# The Knapheide Manufacturing Company

**08V-344**  
**(9 pages)**

On July 15, 2008, The Knapheide Manufacturing Company decided that a safety defect related to motor vehicle safety exists in items of motor vehicle equipment listed below, and is furnishing notification to the National Highway Traffic Safety Administration in accordance with 49CFR Part 573 Defect and Non-Compliance Reports.

This recall includes some Pro Series truck beds built by Knapheide Truck Equipment Company Southwest, 398 North I35 Service Road, Red Oak, Texas 75154 (phone 972-617-3770). Pro Series truck beds that were built between October 23, 2006 and July 15, 2008 and equipped with an ICC bumper which included a provision for a ball hitch are subject to this recall. A sales brochure is attached that shows the ICC bumper/hitch mounted on the rear of the truck bed.

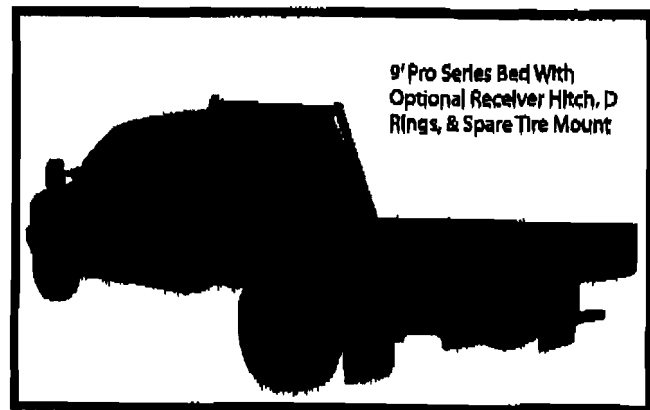
The defect in the ICC bumper/hitch involves the horizontal 4" channel section (hitch channel) to which the ball hitch attaches. On some truck beds there is insufficient weld attaching the hitch

channel to the supporting structure. Knapheide has also become aware that some customers are using the hitch to pull trailers that are beyond the capacity of the hitch channel. The defect can result in bending of the hitch channel or in the worst case the hitch could be pulled off the vehicle. Typically the hitch will fail in bending prior to the hitch coming off the vehicle.

Two remedies for repairing this hitch defect will be offered to customers. For those customers who do not use the hitch, the hitch will be removed from the truck bed and replaced with an ICC bumper. For those customers who need a hitch, a receiver hitch assembly will be added to the existing hitch assembly and all suspect weld joints will be re-welded. The addition of the receiver hitch will prevent the use of a ball hitch and add significant structural strength to the hitch assembly.
